Subject: RAMPP West Virginia LiDAR QA/QC: Tug Watershed Delivery

RAMPP has been tasked and funded by FEMA Region III to perform LiDAR quality assurance and quality control checks for a 3,165km² portion of southern West Virginia. The evaluation will assess the usability of the LiDAR data in supporting the West Virginia Department of Environmental Protection Division of Mining and Reclamation. In addition, the report will comment on the LiDAR's adherence to FEMA's "Procedure Memorandum No. 61 – Standards for LiDAR and Other High Quality Digital Topography." The delivery includes 1,368 LAS tiles. The dataset is referred to as the Tug Watershed delivery.

Figure 2 - Delta-Z ortho image of tile C027661

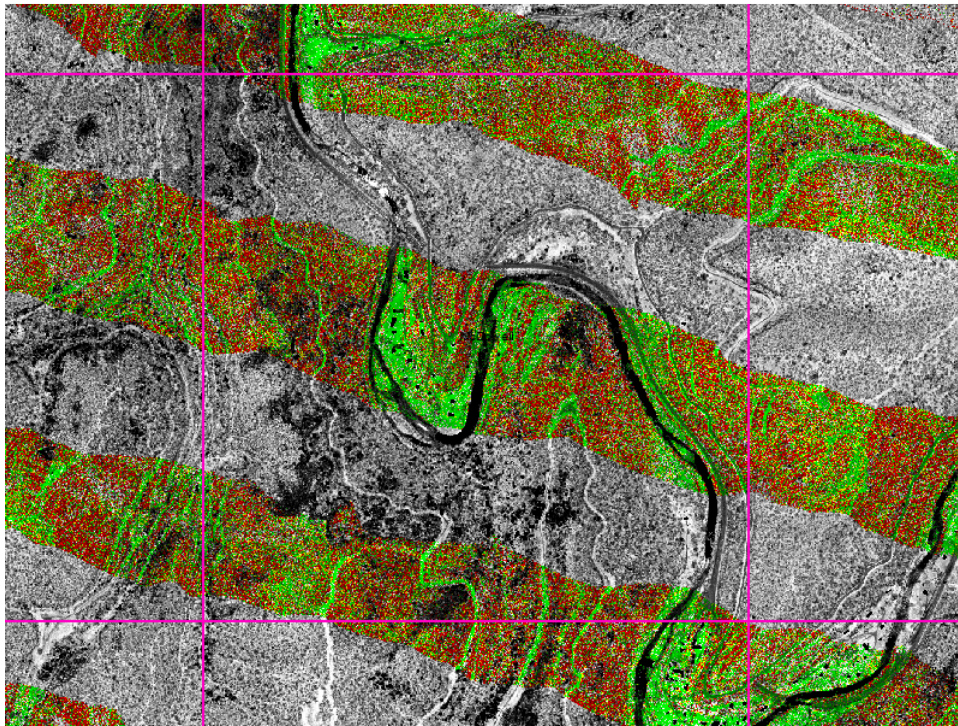
In the image above, the pixel size was 2 meters and the error gradient was 0.15 meters, meaning the green pixels have an error value of less than 0.15 meters, the yellow pixels have an error of 0.15-0.30 meters, and the red pixels have an error of greater than 0.30 meters. Due to the extremely high relief in the project area many of the pixels showing large elevation errors are not reliable. In this situation a higher priority was placed on the low-relief areas, such as the areas around the river and along the roads. The image above is a good example of the quality of the Tug Watershed dataset, where a low delta-Z error is prevalent in the low-relief areas around the river and along the roads.

Figure 4: Aggressive Classification in tile C028413. The purple points are ground and yellow are non-ground.

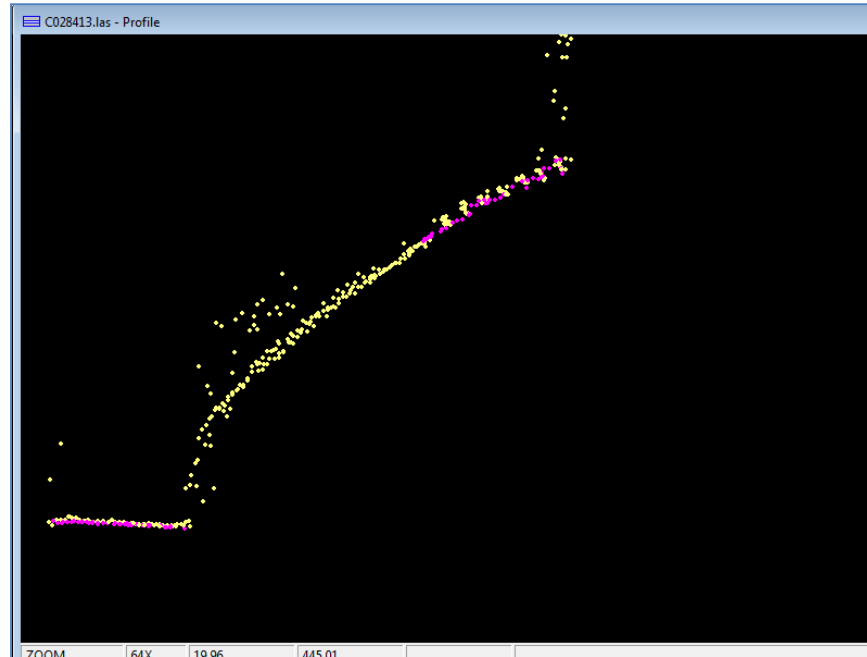
relies on point-to-point distance and angle to determine if a point is ground or non-ground, ground points at the apex of a hill or ridge can be “aggressively” classified out of the ground. Figure 4 below shows ground points in tile C028413 that have been aggressively classified.

Figure 5: Tile C022986 showing vegetation artifacts along the side of the hill

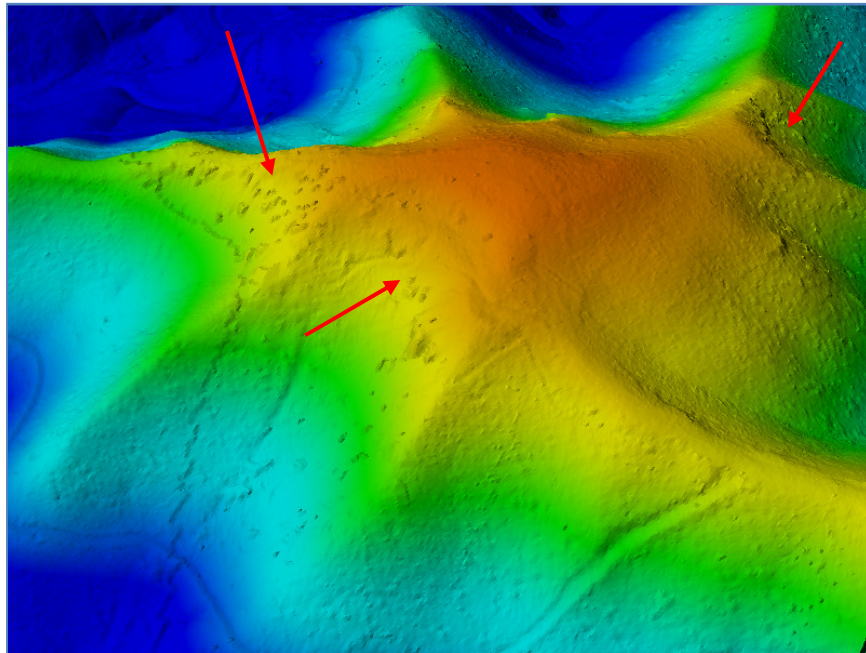
Artifacts are vegetation, buildings, or bridges that are improperly classified as ground points. Most of the non-ground features are classified by the automated ground algorithms in the LiDAR processing software, but it is necessary to manually review the data and remove any remaining non-ground points from the ground surface. Normally a tolerance of 5% of the vegetation artifacts is allowed as manual classification is sometimes subjective and different analysts will interpret the surface differently. Also, bridges with a distinct deck above the ground are normally removed to allow hydro to flow through during flood modeling. Culverts are not normally removed and will be discussed later in this document. The 5% visual review identified over 1300 areas that have vegetation artifacts, over 50 areas with building artifacts, and seven bridge artifacts.

Figure 7: Tile C026594 showing a bridge artifact.

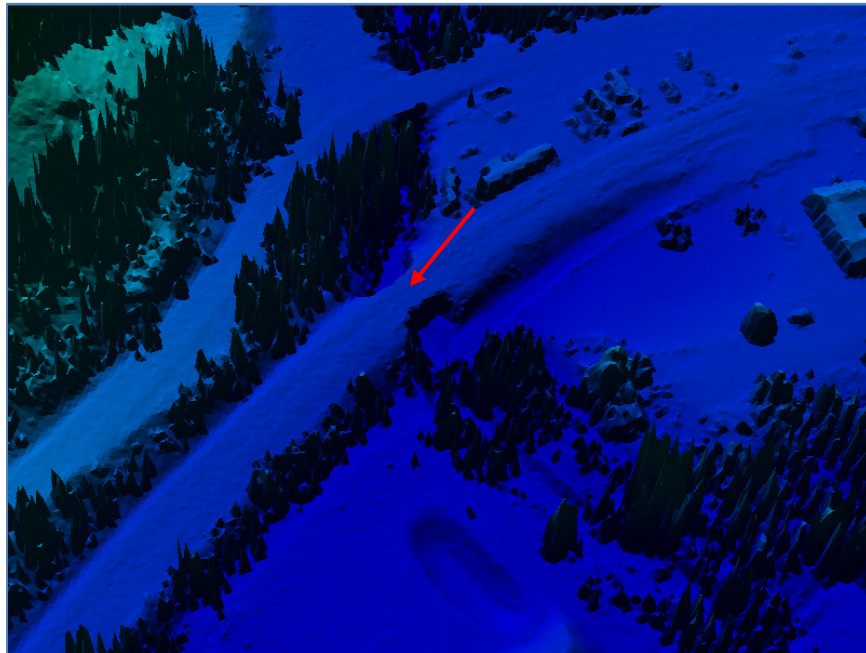
Note that while this image shows the full point cloud, the artifact remains in the ground.

Figure 8: Tile C026363 showing a divot that causes misclassification of the ground surface

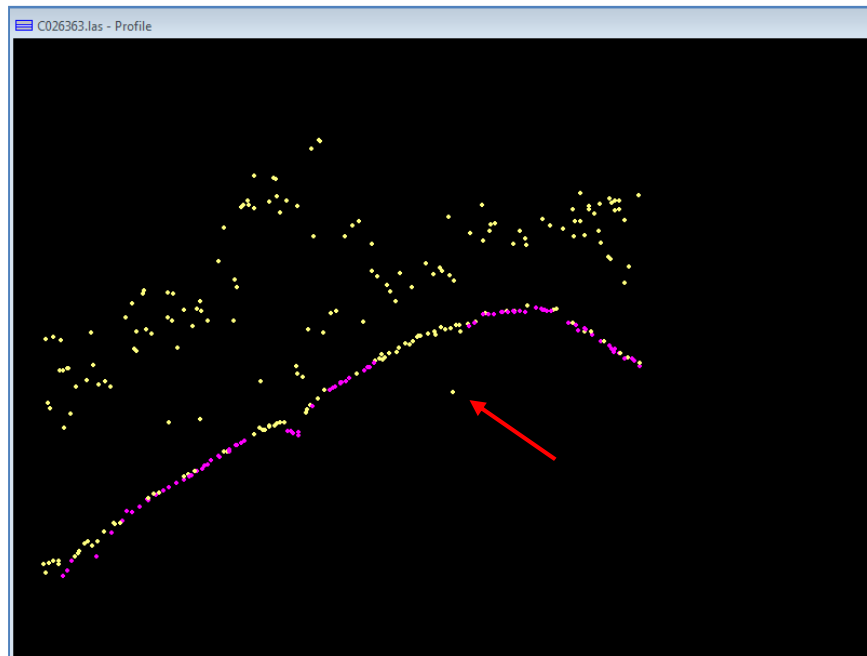
Divots are points that fall far below the expected ground surface. They can occur because of a timing error in the LiDAR sensor or near buildings where the LiDAR pulse is distorted by glass. Because the LiDAR processing software looks for the lowest point near the previously classified ground, the divots are marked as ground and the true ground is treated as non-ground.

Figure 9: Tile C027456 showing a flight line ridge with an offset of over 0.6 meters

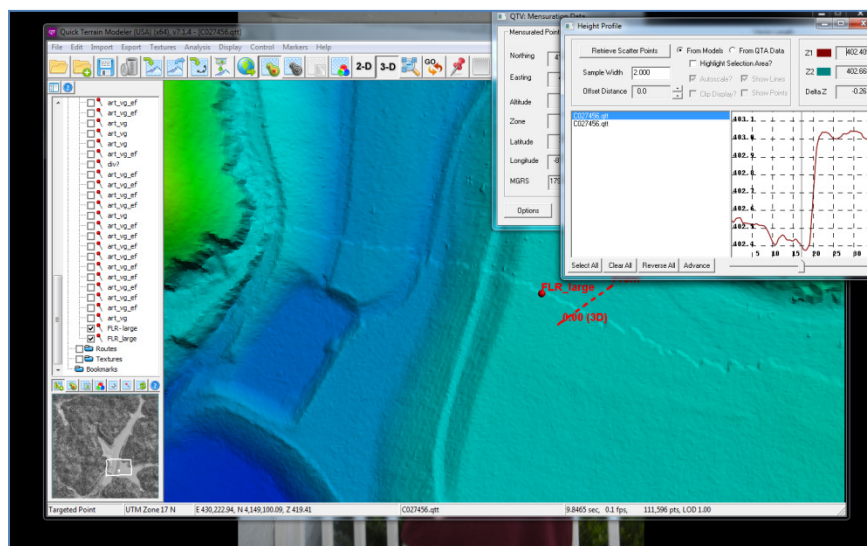
Flight line ridges or seamlines occur when two or more overlapping flight lines are not calibrated correctly. While the review of the Delta-Z ortho images in the completeness check did not find any project-wide calibration errors, several localized issues exist. The data should be recalibrated or reclassified to reduce the ridge to within the accuracy specification set forth in the Statement of Work.

Figure 10: Tile C026478 showing ground points removed from a culvert

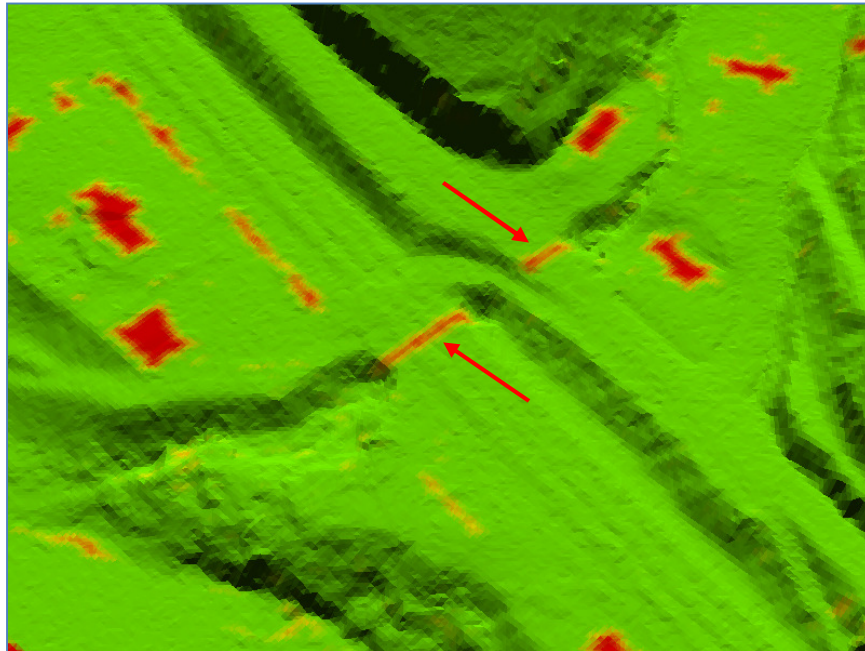
A culvert is a feature that allows hydro to flow underneath a road, but unlike a bridge, does not have a man-made deck above the ground surface. A culvert can be differentiated from a bridge because it has visible ground between the road and the hydro surface. As mentioned above in the Artifacts section, culverts should be left in the ground.

Figure 13: Checkpoint Delta-Z by Land Cover Type

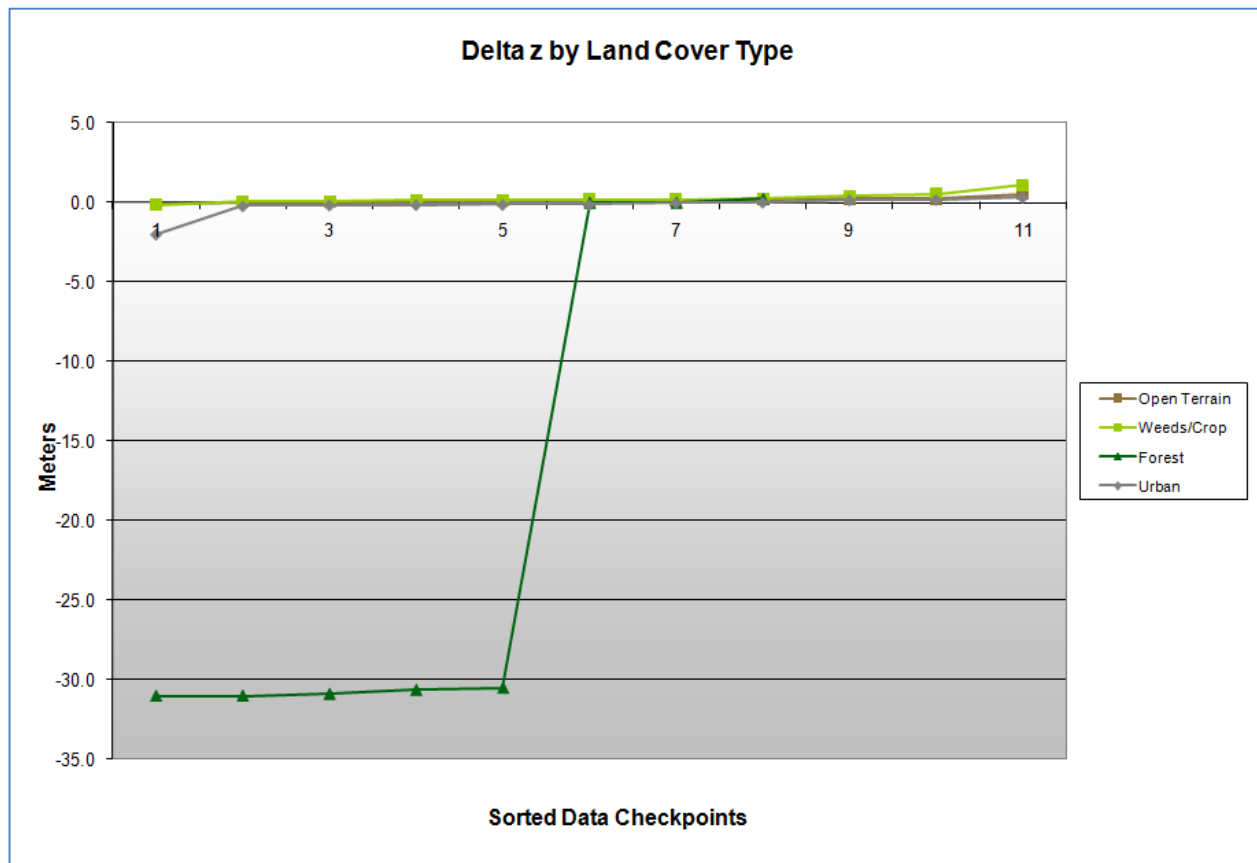
Vertical accuracy was calculated for each land cover type and for the consolidated checkpoints. The Tug Watershed LiDAR does not meet the vertical accuracy requirements due to significant elevation error in some of the tiles.

***Note – As of 3/15/2012, the LiDAR provider is aware of the 30 meter offset error in the McDowell County and is correcting the issue.
